APPLICATION FOR PERMIT TO DRILL OR REENTER

8. Lease Name and Well No.
WILLOW LAKE 35-W0DM
1H 325942

APPROVED WITH CONDITIONS

PECOS DISTRICT
DRILLING CONDITIONS OF APPROVAL

Figure 1. Cross-sections and plans for typical road sections representative of BLM resource or FS local and higher-class roads.

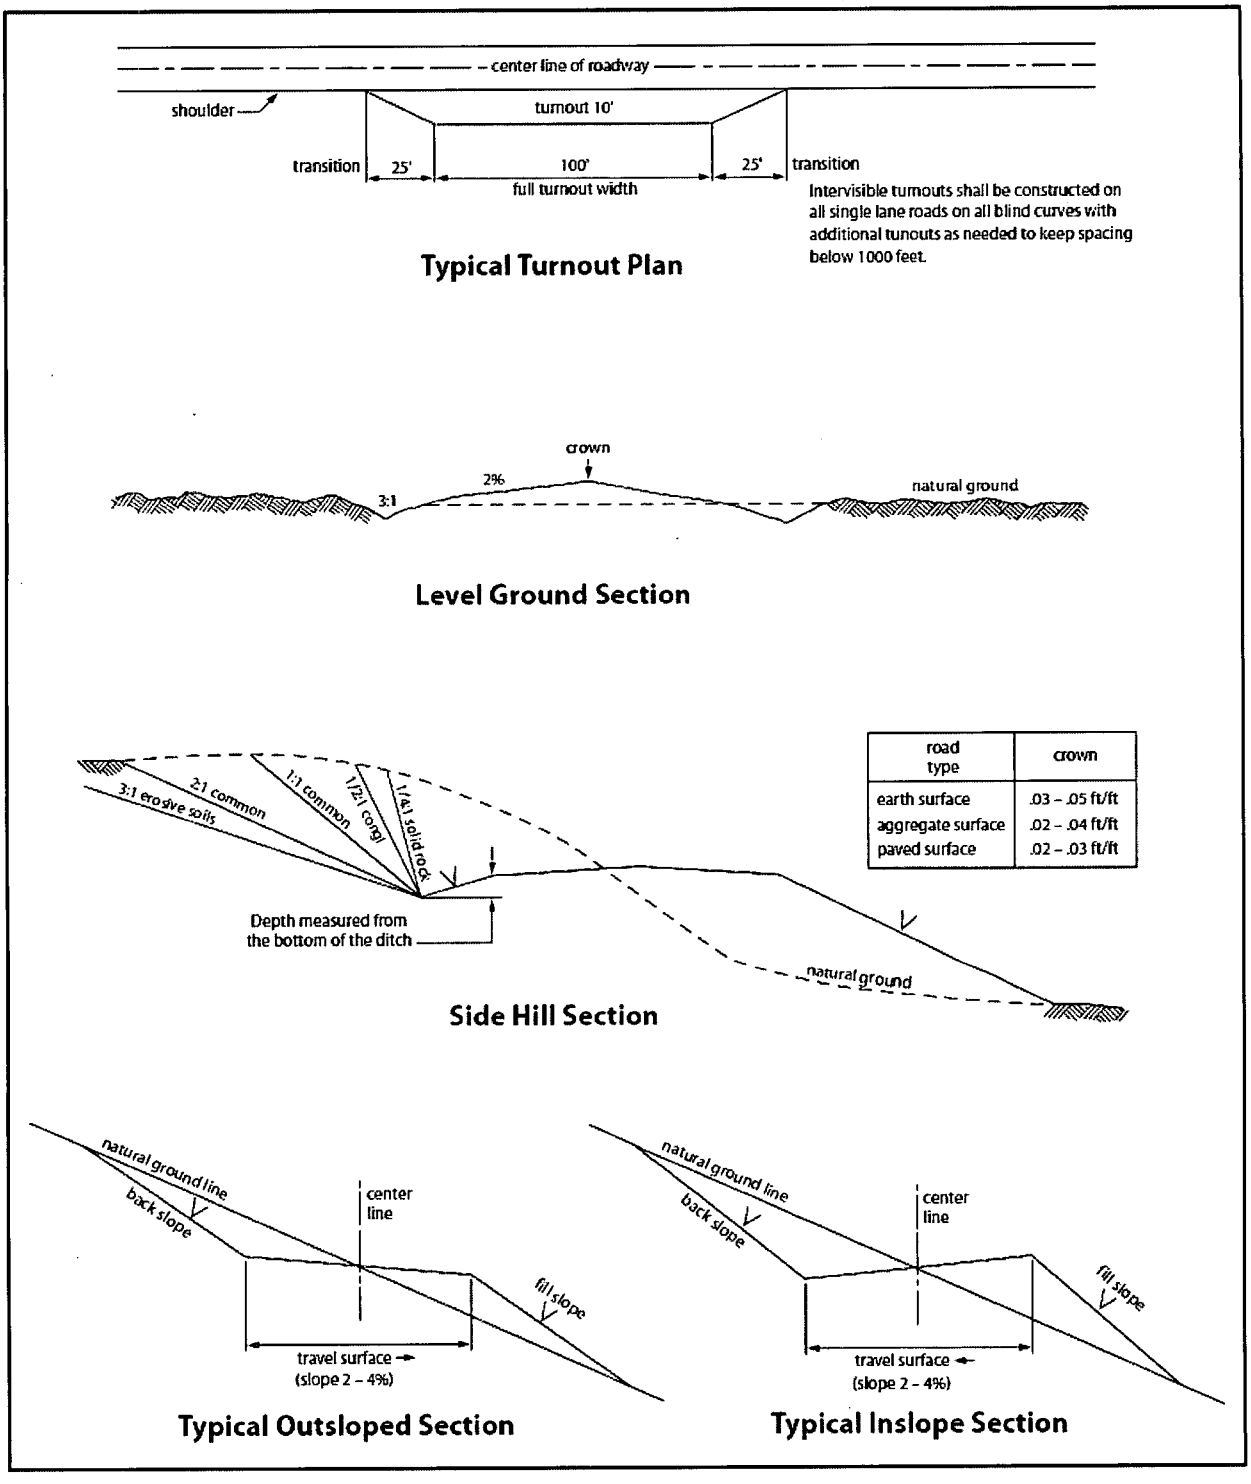
Crowning
Crowning shall be done on the access road driving surface. The road crown shall have a grade of approximately 2% (i.e., a 1" crown on a 14' wide road). The road shall conform to Figure 1; cross section and plans for typical road construction.

Turnouts
Vehicle turnouts shall be constructed on the road. Turnouts shall be intervisible with interval spacing distance less than 1000 feet. Turnouts shall conform to Figure 1; cross section and plans for typical road construction.

5M BOPE & Closed Loop Equipment Schematic

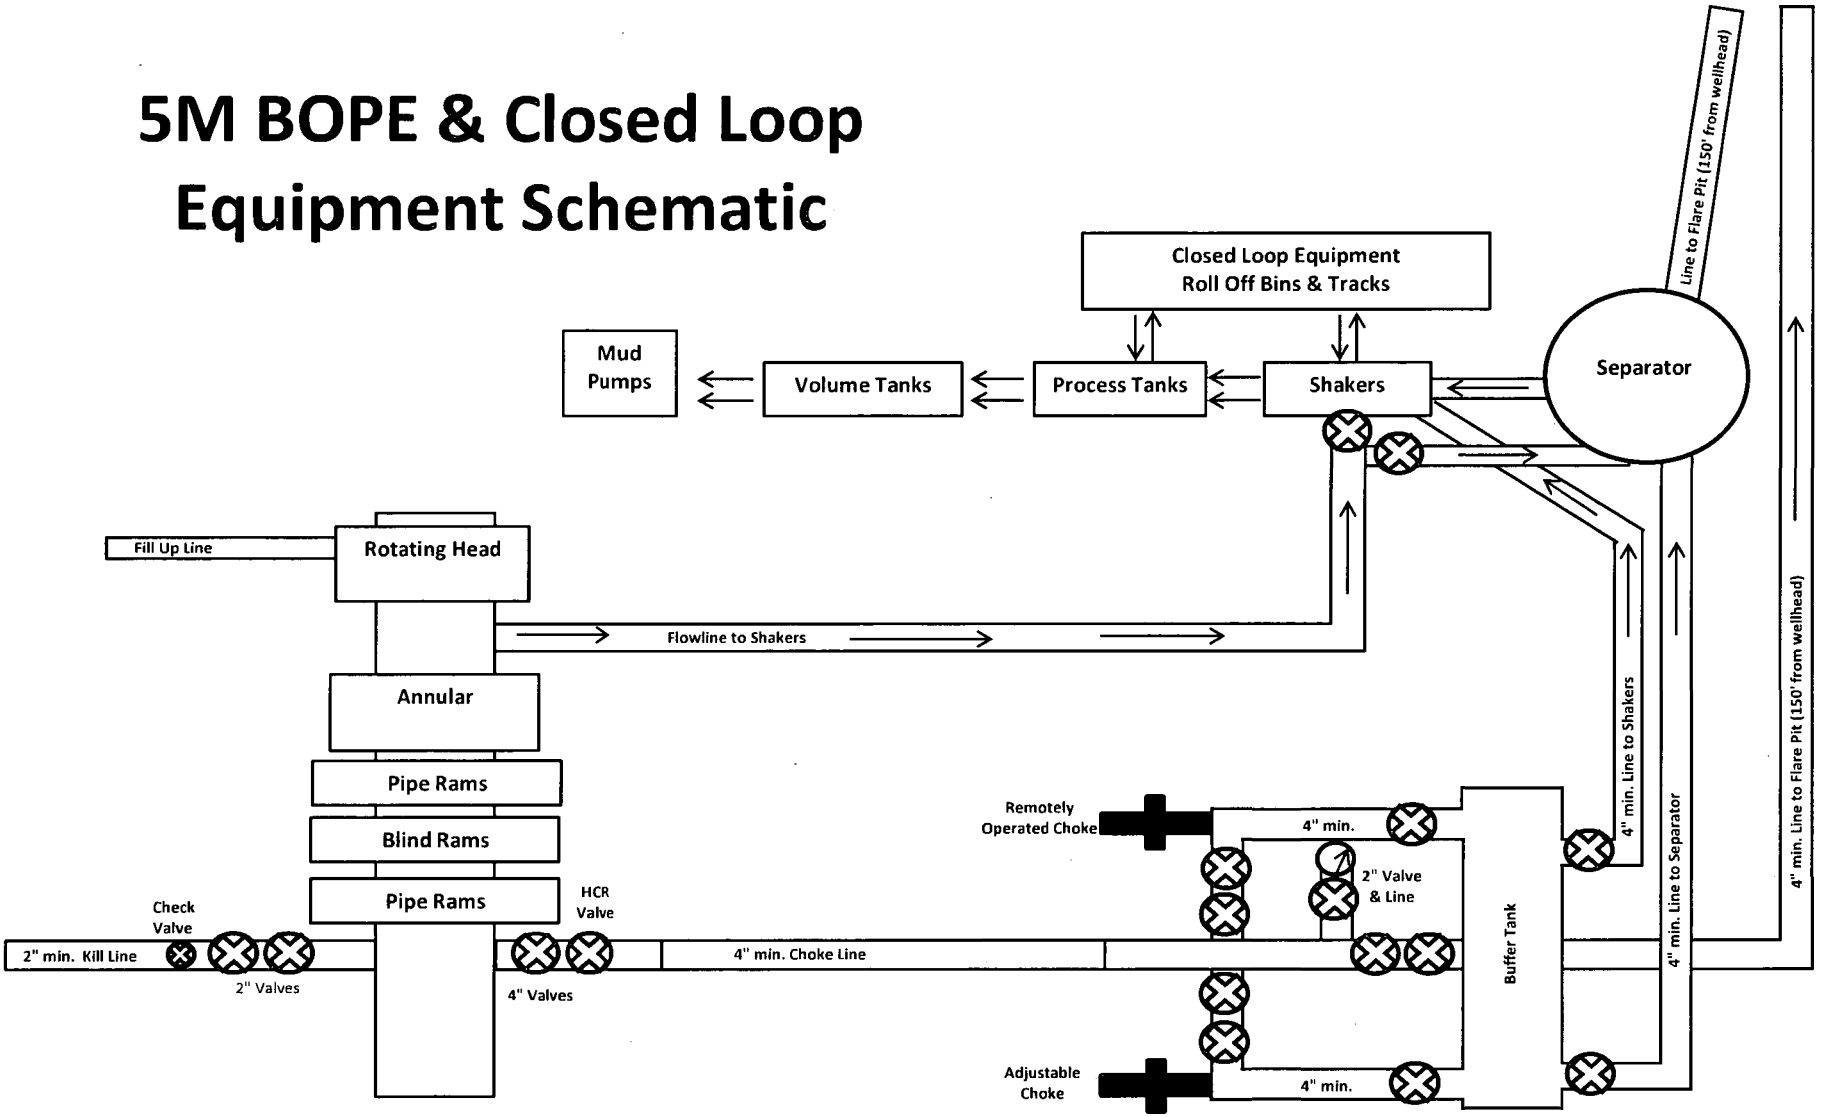
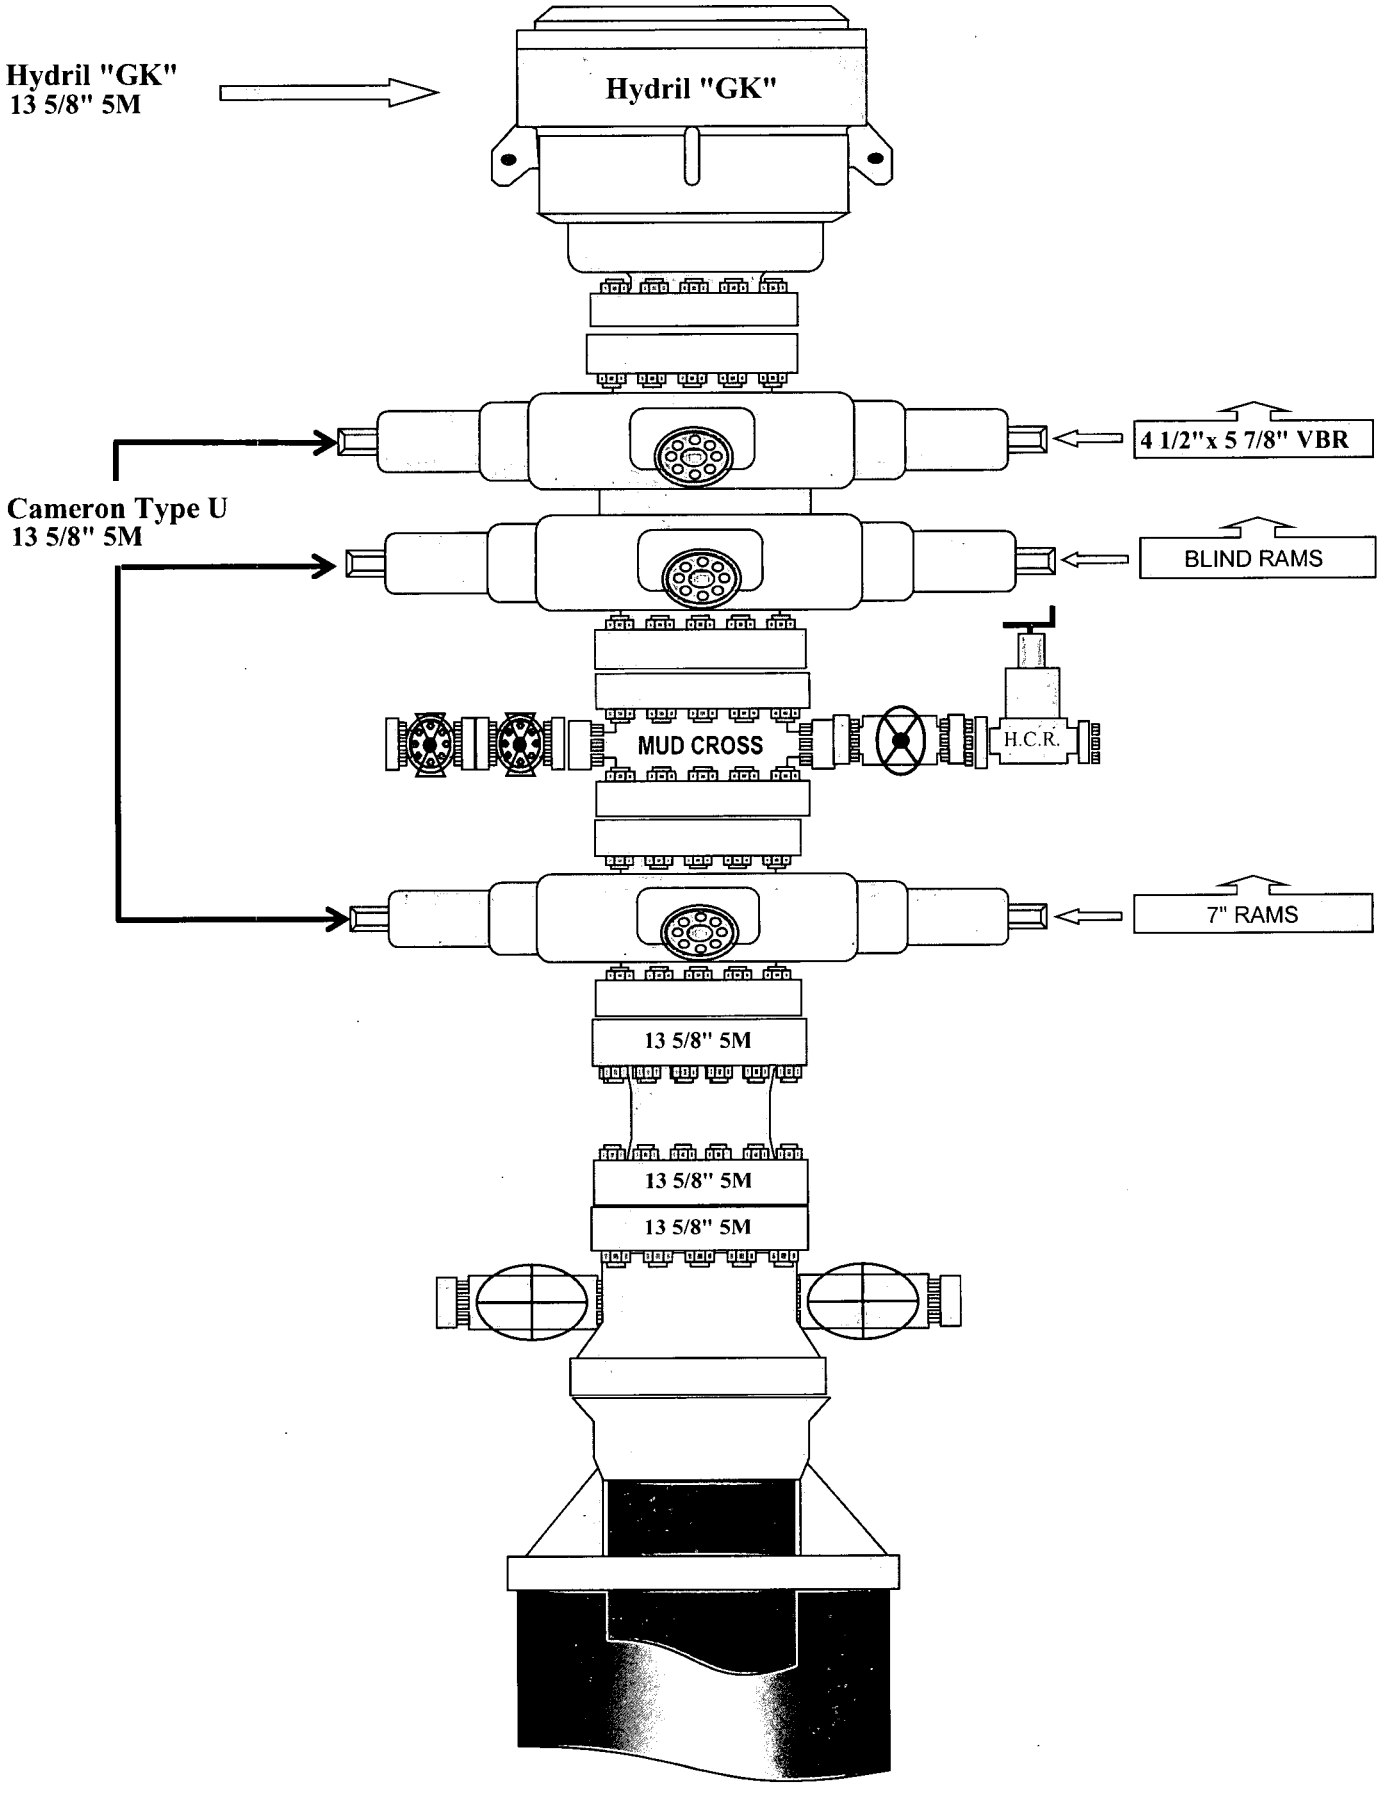
1. Variance approved to use flex line from BOP to choke manifold. Manufacturer's specification to be readily available. No external damage to flex line. Flex line to be installed as straight as possible (no hard bends).'

2. If a variance is approved for a flexible hose to be installed from the BOP to the choke manifold, the following requirements apply: Check condition of flexible line from BOP to choke manifold, replace if exterior is damaged or if line fails test. Line to be as straight as possible with no hard bends and is to be anchored according to Manufacturer's requirements. The flexible hose can be exchanged with a hose of equal size and equal or greater pressure rating. Anchor requirements, specification sheet and hydrostatic pressure test certification matching the hose in service, to be onsite for review. These documents shall be posted in the company man's trailer and on the rig floor.

3. 5M or higher system requires an HCR valve, remote kill line and annular to match. The remote kill line is to be installed prior to testing the system and tested to stack pressure.

13-5/8" MN-DS Wellhead System

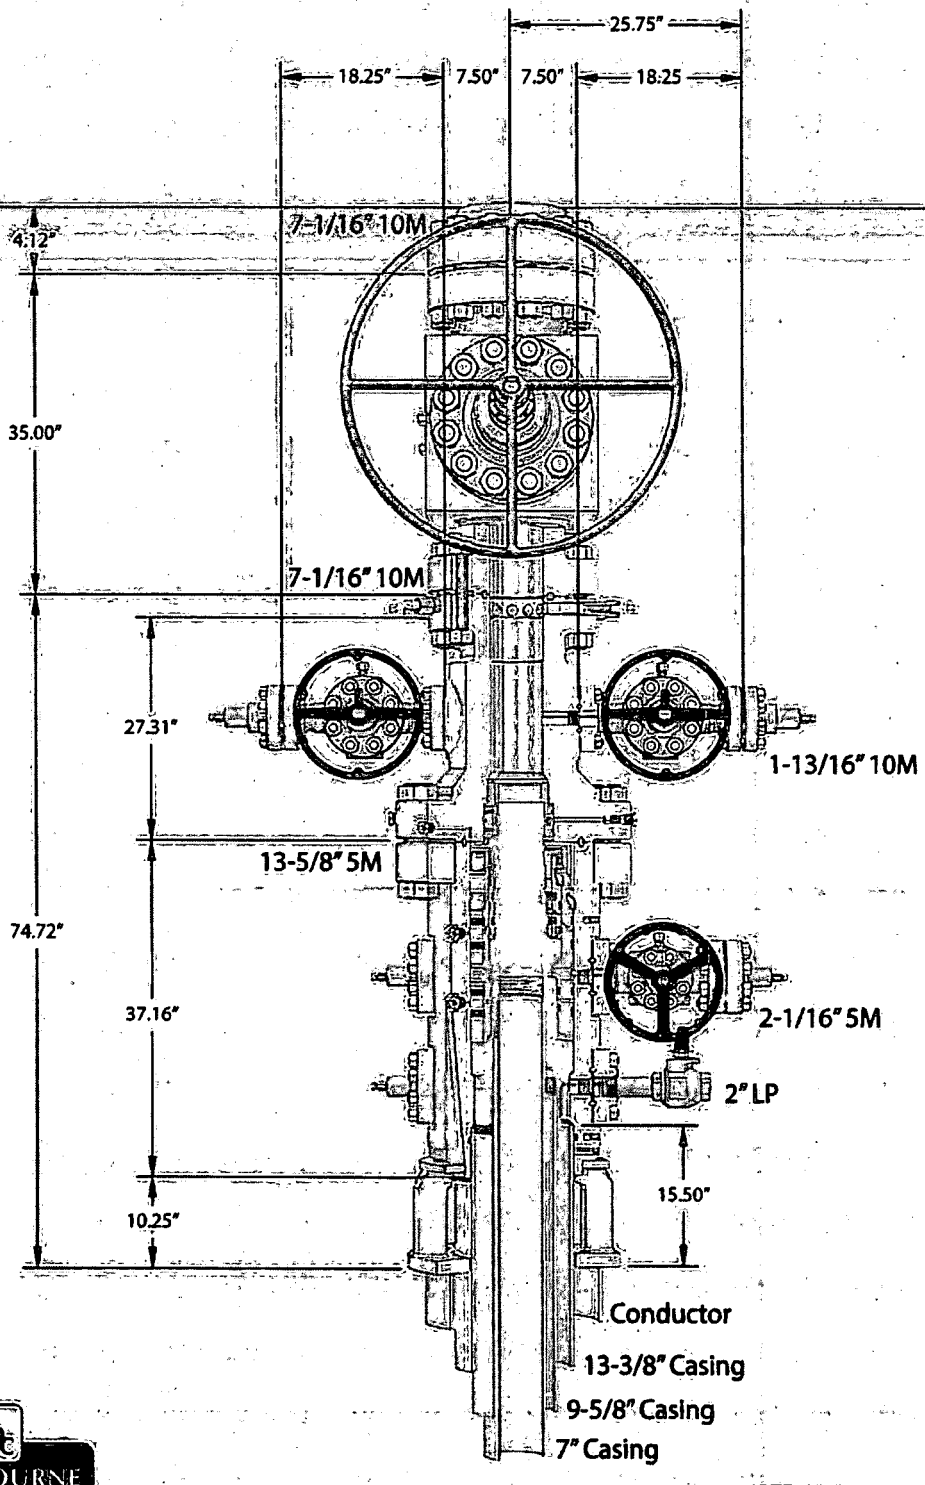
1. Operator has proposed a multi-bowl wellhead assembly. This assembly will only be tested when installed on the surface casing. Minimum working pressure of the blowout preventer (BOP) and related equipment (BOPE) required for drilling below the surface casing shoe shall be **5000 (5M)** psi.

a. Wellhead shall be installed by manufacturer's representatives, submit documentation with subsequent sundry.
    b. If the welding is performed by a third party, the manufacturer's representative shall monitor the temperature to verify that it does not exceed the maximum temperature of the seal.
    c. Manufacturer representative shall install the test plug for the initial BOP test.
    d. If the cement does not circulate and one inch operations would have been possible with a standard wellhead, the well head shall be cut off, cementing operations performed and another wellhead installed.
    e. Whenever any seal subject to test pressure is broken, all the tests in OOGO2.III.A.2.i must be followed.

4. If the operator has proposed a multi-bowl wellhead assembly in the APD. The following requirements must be met:

a. Wellhead shall be installed by manufacturer's representatives, submit documentation with subsequent sundry.
    b. If the welding is performed by a third party, the manufacturer's representative shall monitor the temperature to verify that it does not exceed the maximum temperature of the seal.
    c. Manufacturer representative shall install the test plug for the initial BOP test.
    d. Whenever any seal subject to test pressure is broken, all the tests in OOGO2.III.A.2.i must be followed.
    e. If the cement does not circulate and one inch operations would have been possible with a standard wellhead, the well head shall be cut off, cementing operations performed and another wellhead installed.
